Access Compliance Report

Public Rights-of-Way

| Intersection ID: 12048 | Main Street: S_GRAHAM_ST | Cross Street: W_3RD_ST | Location: W |
| ADA ID: F2B03D95E04E | Ramp Type: Perp | Initial Pass/Fail: Pass | Overall Compliance: No |

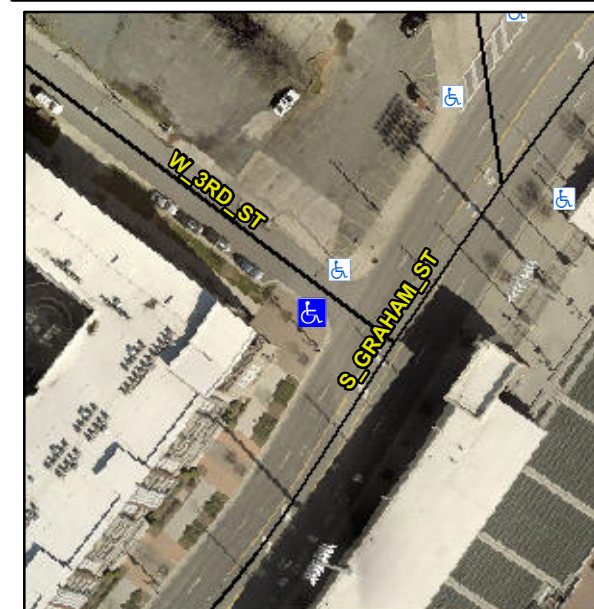
**R304.2.2-Perp, R304.3.2-Para,
R304.2.3, R305.2**

| Compliance | Description | Data | Compliance | Description | Data |
|------------|-----------------------|------------------------|------------|-----------------------------|------|
| No | Flare Type | Curbed_WithWalkSurface | No | Flare Type RT | N/A |
| No | Flare Slope LT (%) | N/A | N/A | Flare Slope RT (%) | N/A |
| No | Landing Slope (%) | 2.8 | Yes | DWS Length (in) | 24.0 |
| N/A | Landing Curb? (Y/N) | No | No | DWS Offset (in) | 4.0 |

Remove & Replace Entire Ramp.
